WYOMING ESTATES SUBDIVISION

FINAL DRAINAGE REPORT

PCD File No. MS 196

FINAL DRAINAGE REPORT
WYOMING ESTATES SUBDIVISION

DRAINAGE PLAN
 DEVELOPED
 CONDITIONS

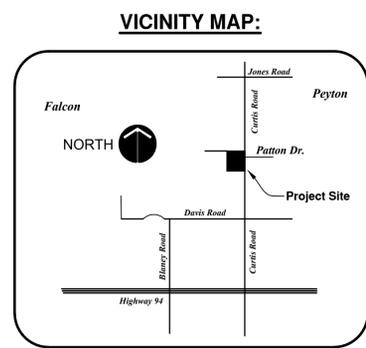
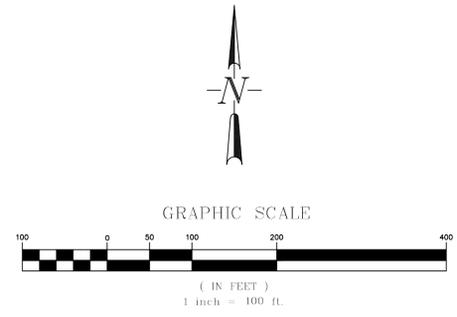
It does not appear that the contours as shown on the GEC and CD will convey the flows from the roadside ditches to the ponds. Please revise accordingly.

Review 2 comment: Please address any permanent stormwater quality control measure in your narrative and provide discussion on how the developed runoff will be conveyed to the permanent control measure. Additionally provide the appropriate construction documents for any permanent water quality facilities.
 Review 3: Provide pond details in your Construction Documents for the proposed water quality ponds

Per the rain garden calculations it appears that an underdrain will not be provided and that a full infiltration section will be provided. Please refer to urban drainage flood control district Volume 3 fact sheets T-3 for requirements for a full infiltration section. For instance it indicates that on-site infiltration tests using a double-ring infiltrometer shall be performed. Please be sure to provide a note on the construction documents of the pond that on-site infiltration test as stated above shall be performed.
